Wisconsin Department of Transportation

Proposal #23: 6170-00-61
C Wautoma, S Cambridge St
STH 22 S to STH 22 N
STH 21
Waushara County

6310-00-60, WISC 2021 180
Princeton - Plainfield
STH 22 S to CTH BB
STH 73
Waushara County

This is Addendum No. 02, which provides for the following:

Addendum No. 02
 ID 6310-00-60
 Revised Sheet 27
 February 3, 2021

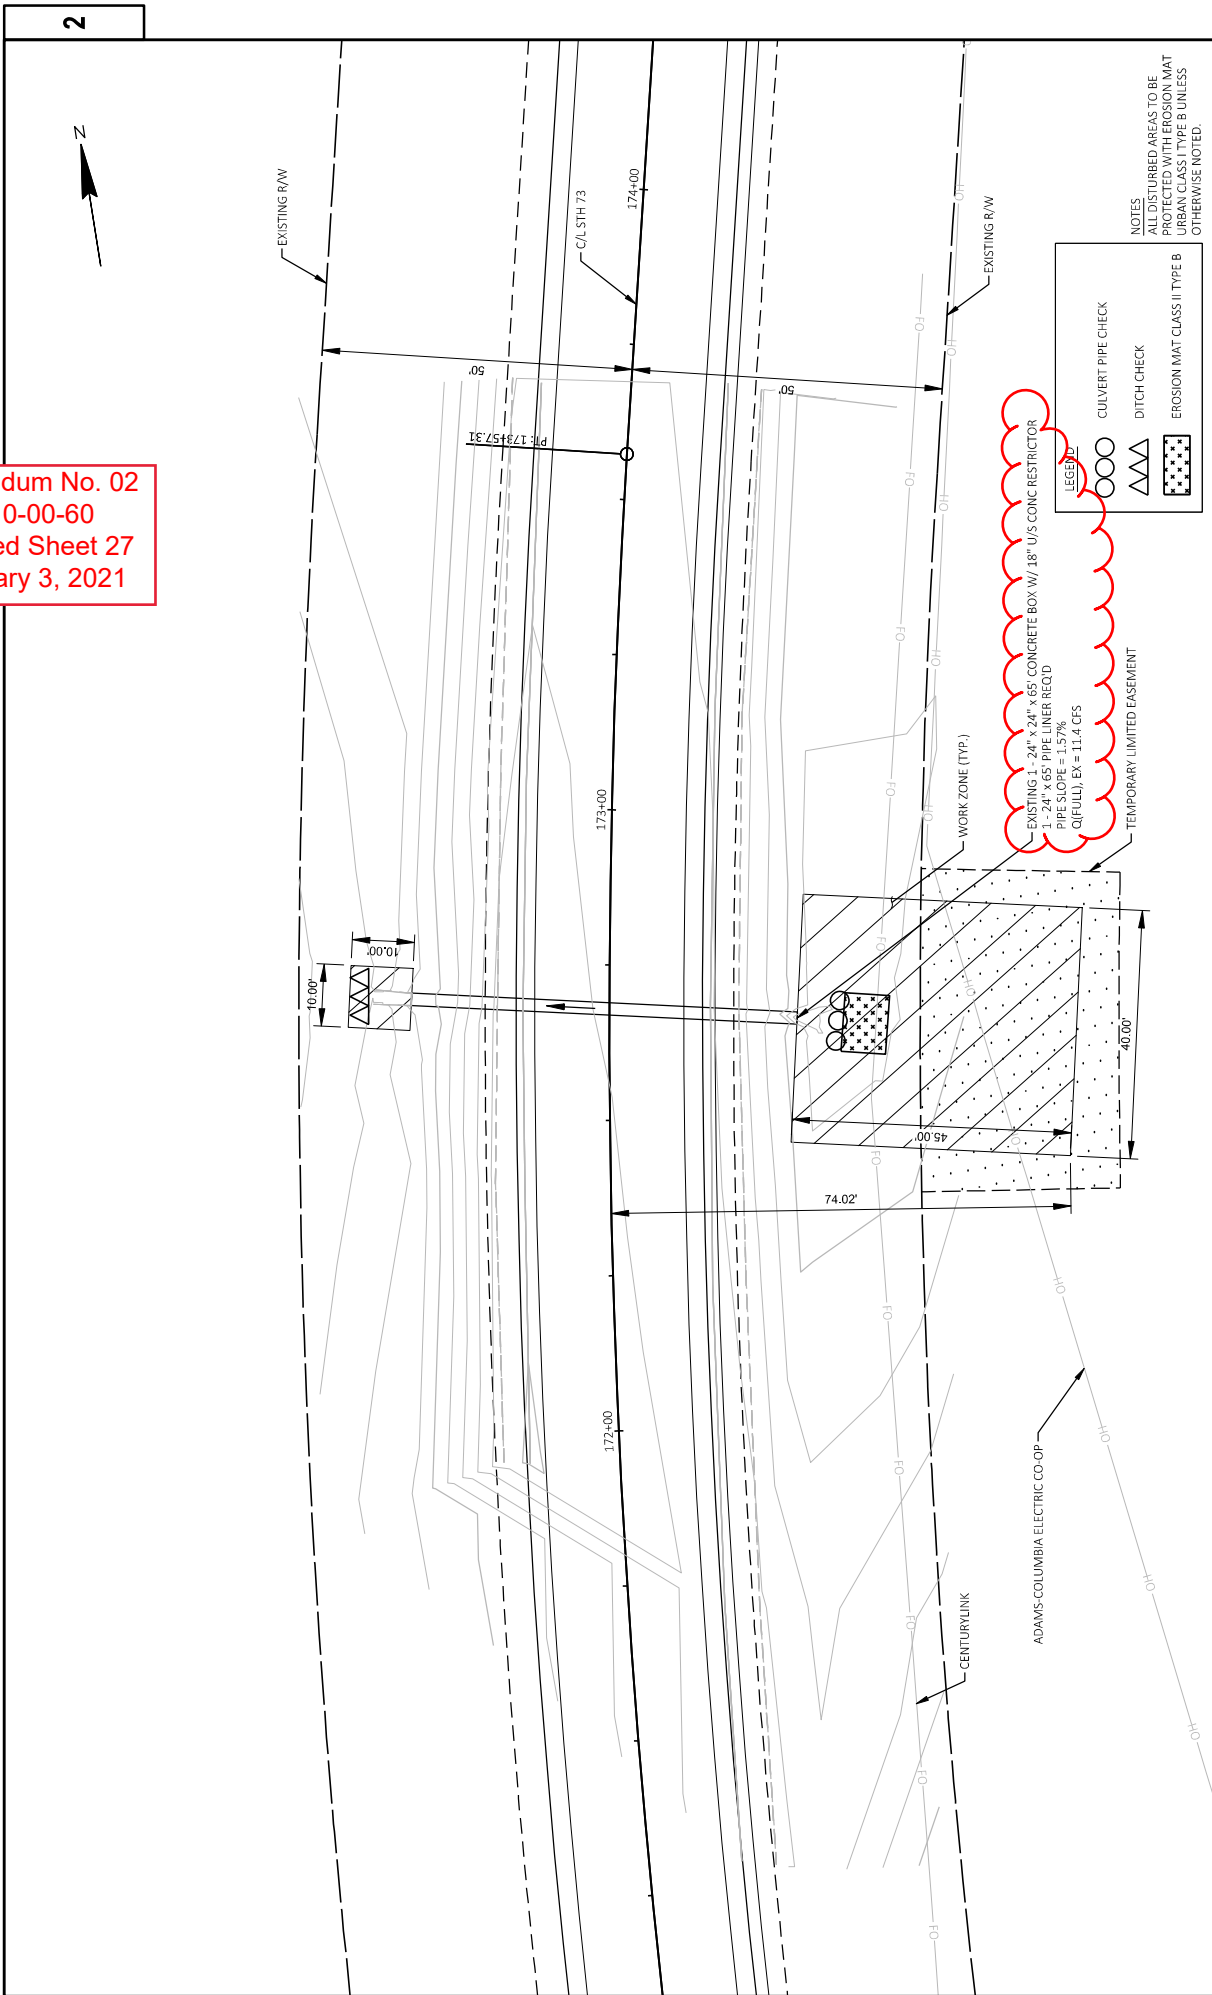
Revised Plan Sheets – 6310-00-60	
Plan Sheet	Plan Sheet Title (brief description of changes to sheet)
26	Removed Liner Size, Revised Existing Q(full)
27	Removed Liner Size, Revised Existing Q(full)
28	Removed Liner Size, Revised Existing Q(full)
29	Removed Liner Size, Revised Existing Q(full)
30	Removed Liner Size, Revised Existing Q(full)
31	Item Change for Pipe Culverts
32	Item Change for Pipe Culverts
33	Item Change for Pipe Culverts
34	Removed Liner Size, Revised Existing Q(full)
50	Item Revisions in Miscellaneous Quantities for Pipe Culverts
55	Added Item of Slope Staking in Miscellaneous Quantities
66	Item Change for Pipe Culverts
69	Item Change for Pipe Culverts
70	Item Change for Pipe Culverts

Addendum No. 02
 ID 6310-00-60
 Revised Sheet 28
 February 3, 2021

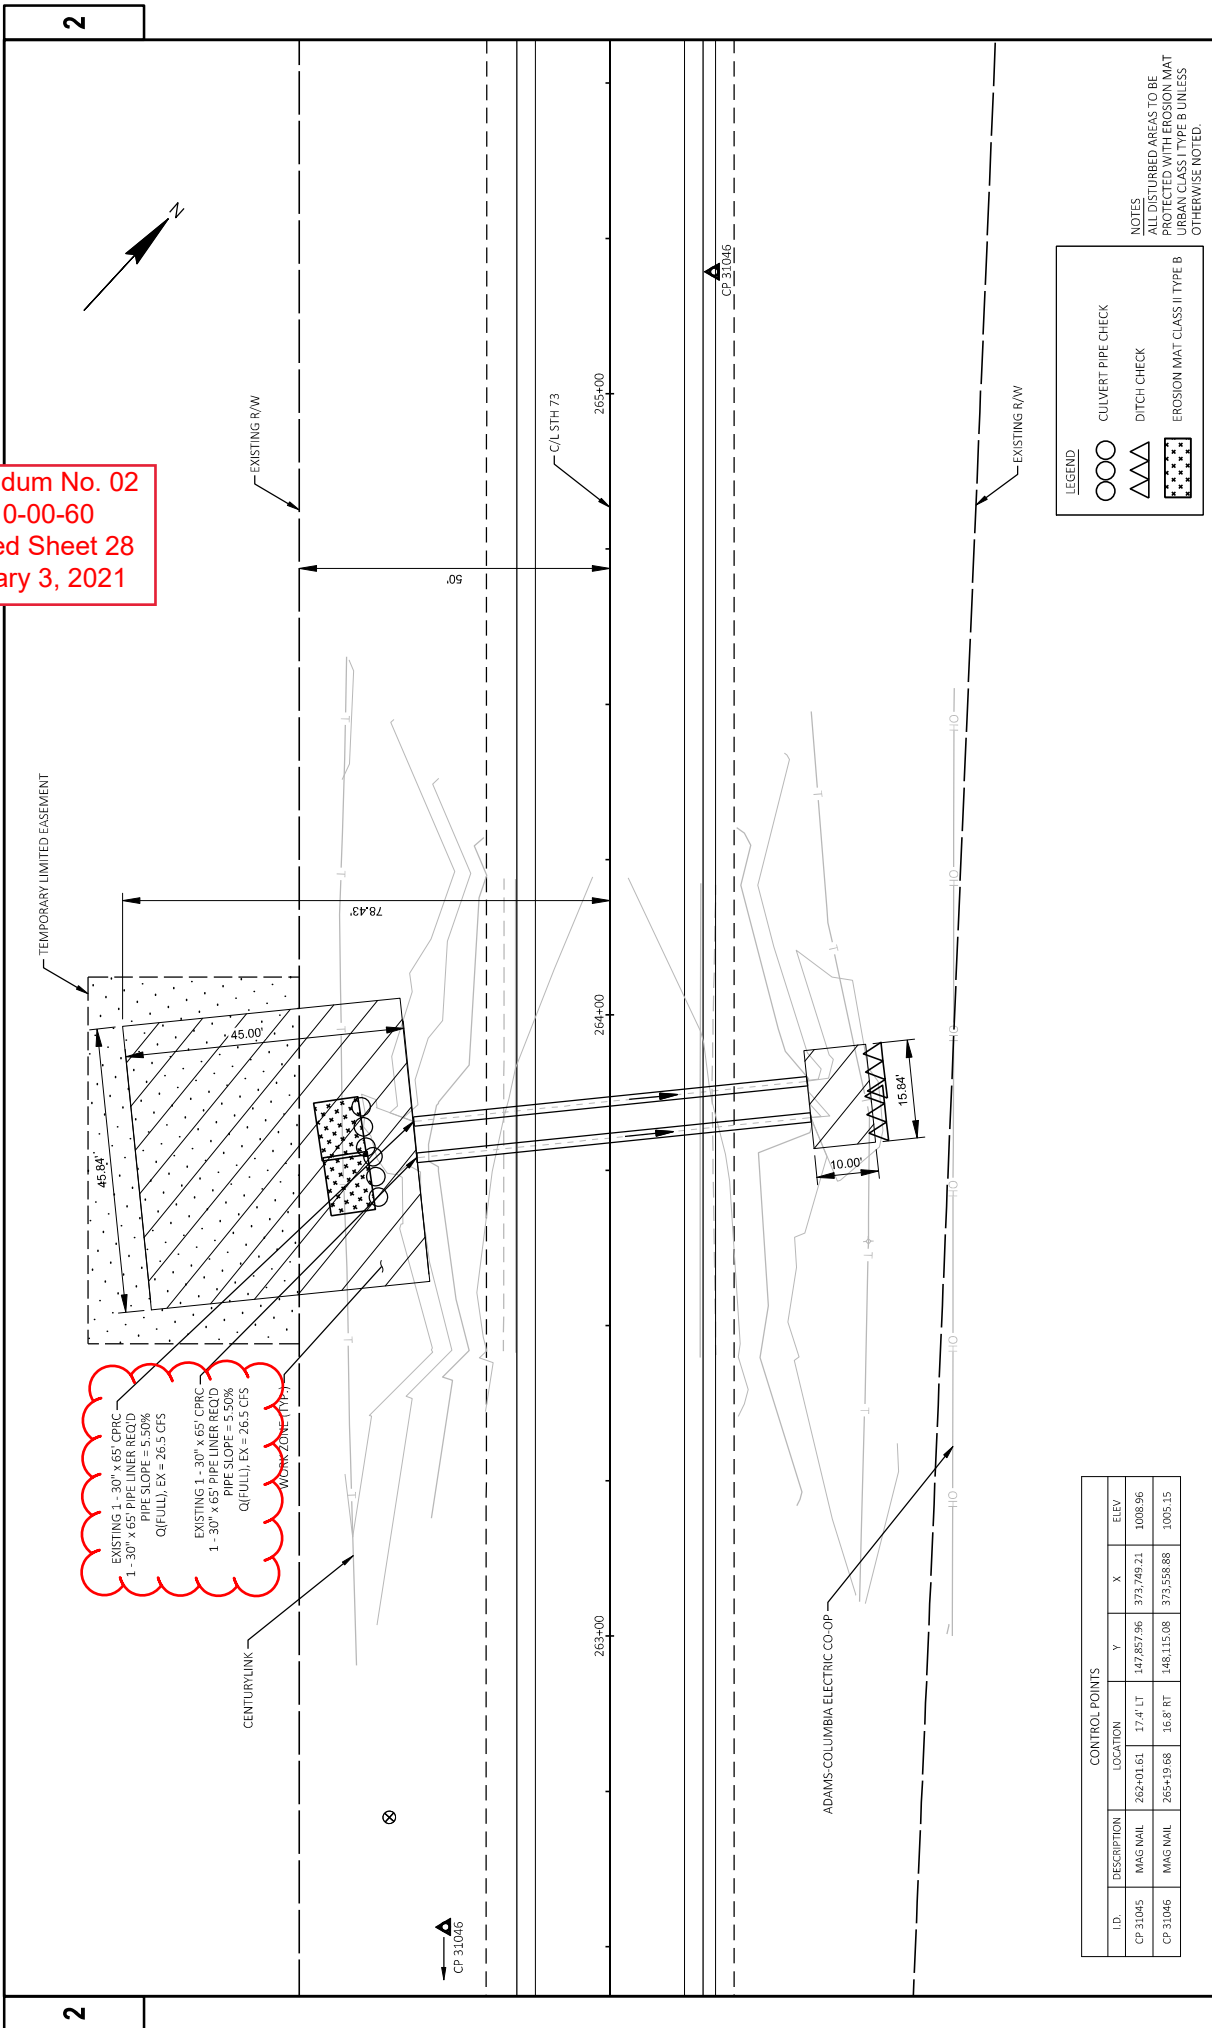
EXISTING 1 - 30" x 65" CP RC
 PIPE LINER REQ'D
 PIPE SLOPE = 5.50%
 Q(FULL); EX = 26.5 CFS

Addendum No. 02
 ID 6310-00-60
 Revised Sheet 31
 February 3, 2021

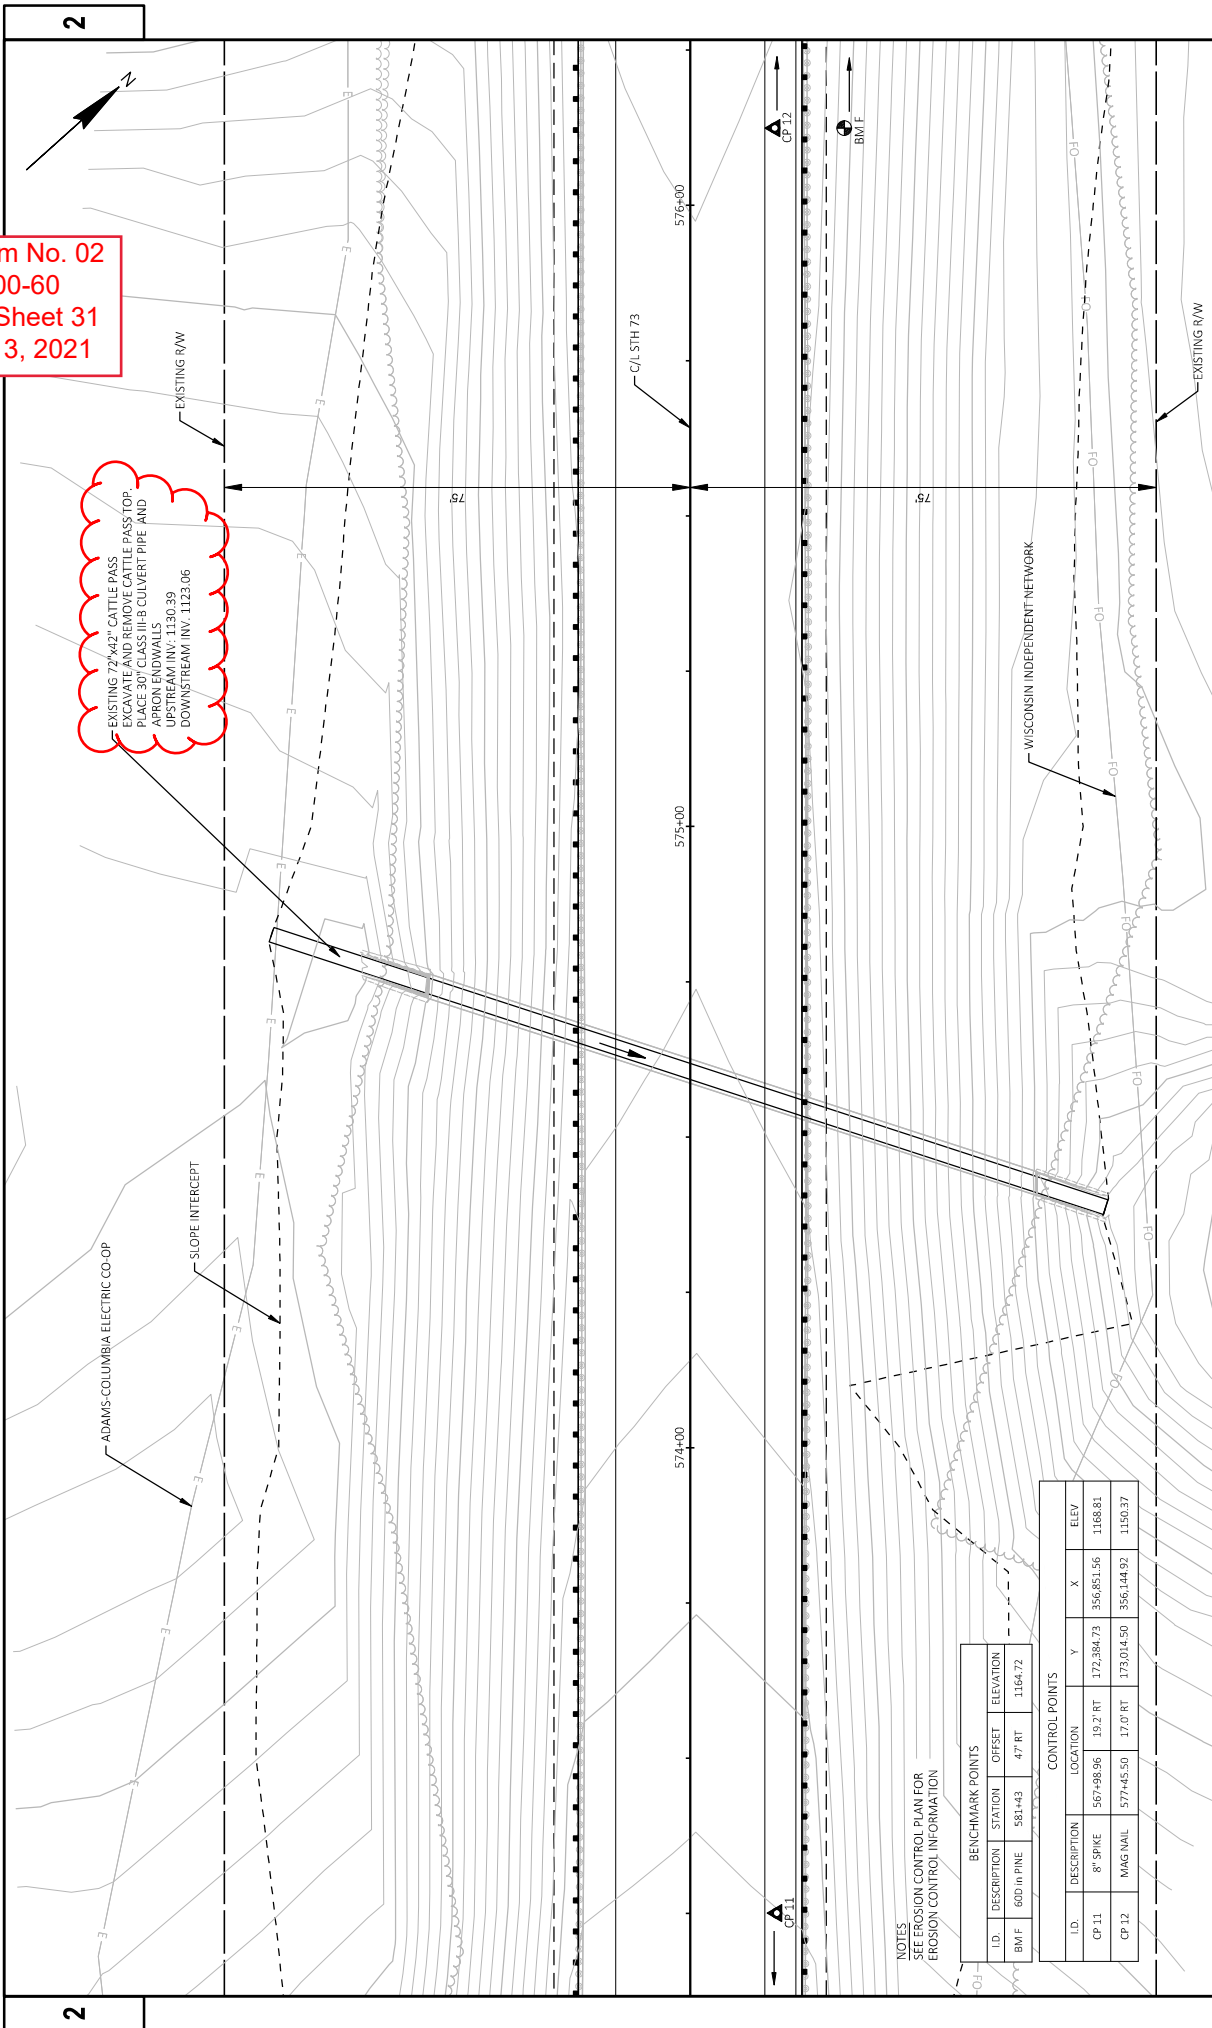
EXISTING 72"x42" CATTLE PASS
 EXCAVATE AND REMOVE CATTLE PASS TOP
 PLACE 30" CLASS III-B CULVERT PIPE AND
 APRON ENDWALLS
 UPSTREAM INV: 1130.39
 DOWNSTREAM INV: 1123.06

Addendum No. 02
 ID 6310-00-60
 Revised Sheet 32
 February 3, 2021

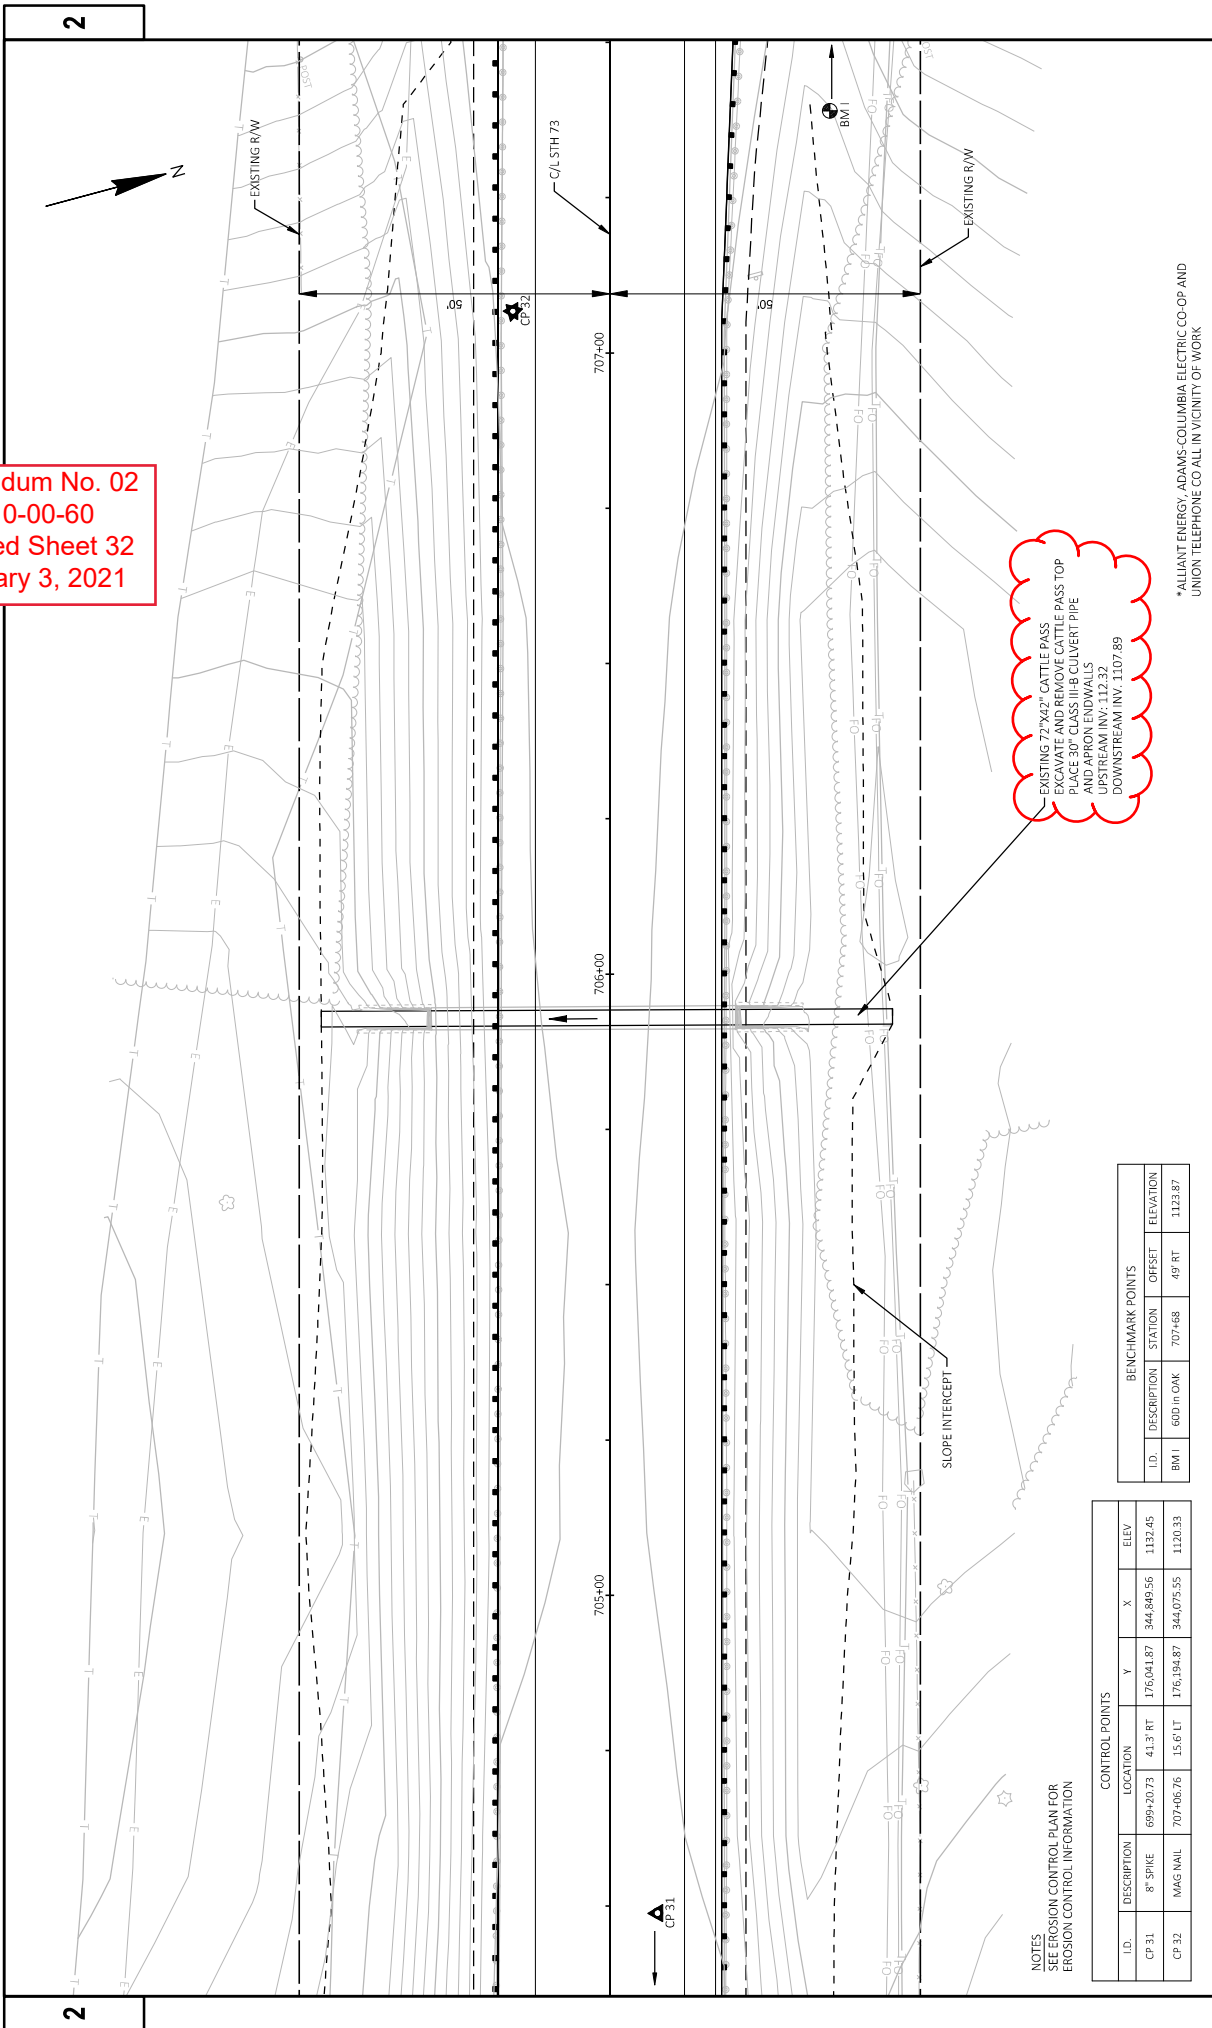
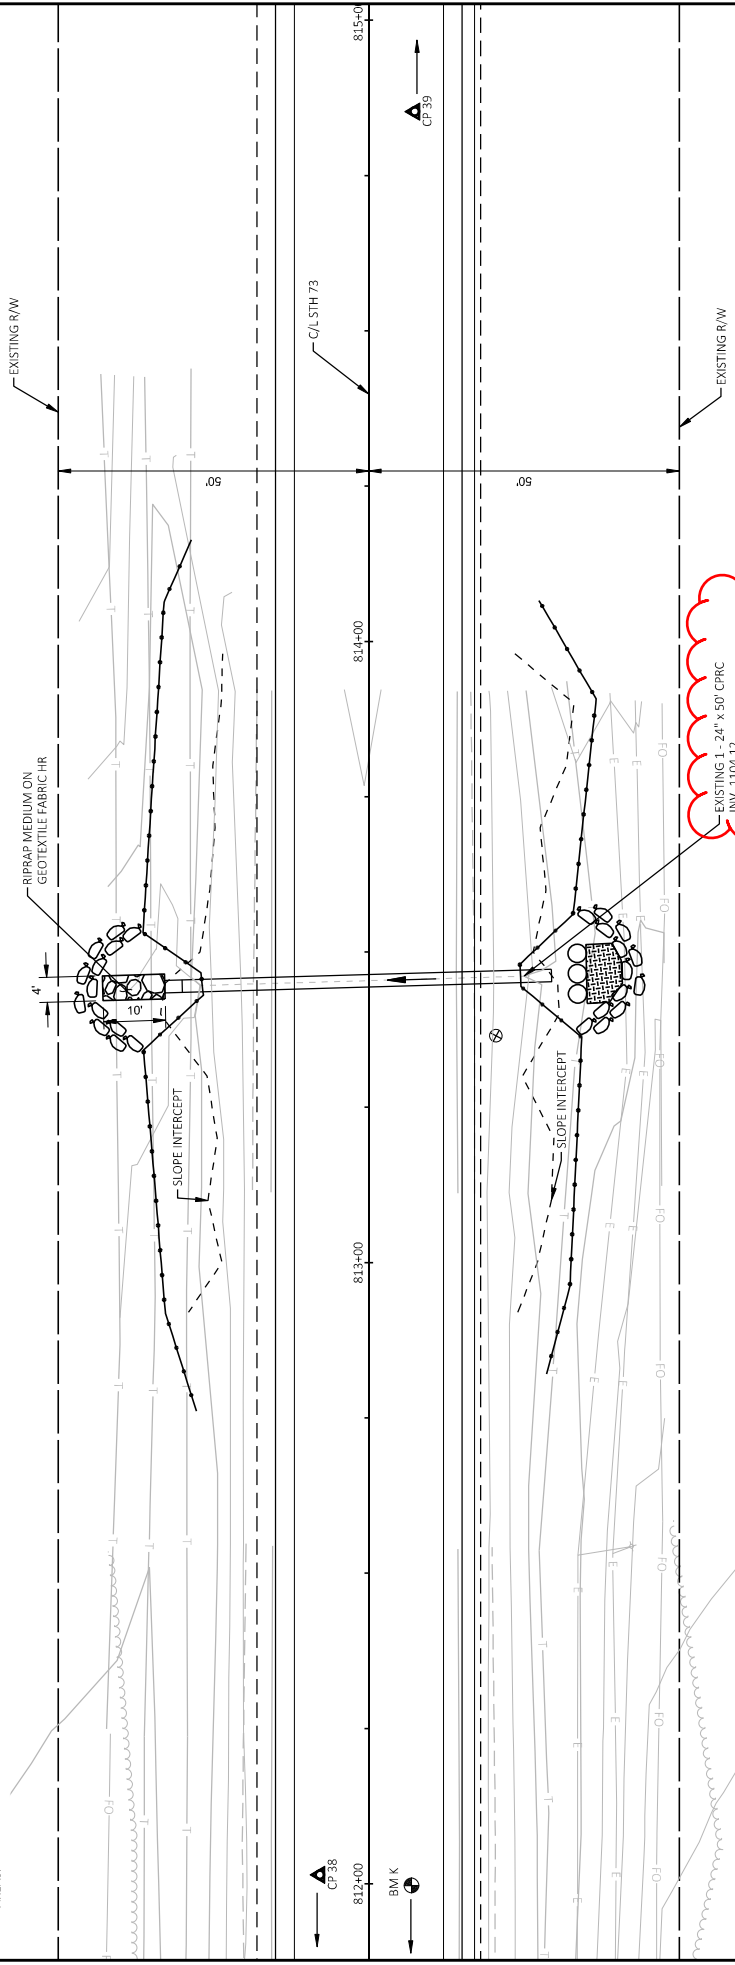
EXISTING 72"x42" CATTLE PASS
 EXCAVATE AND REMOVE CATTLE PASS TOP
 AND REINSTALL CULVERT PIPE
 AND APPROX 15' ENDWALLS
 (UPSTREAM INV: 112.33
 DOWNSTREAM INV: 1107.89)
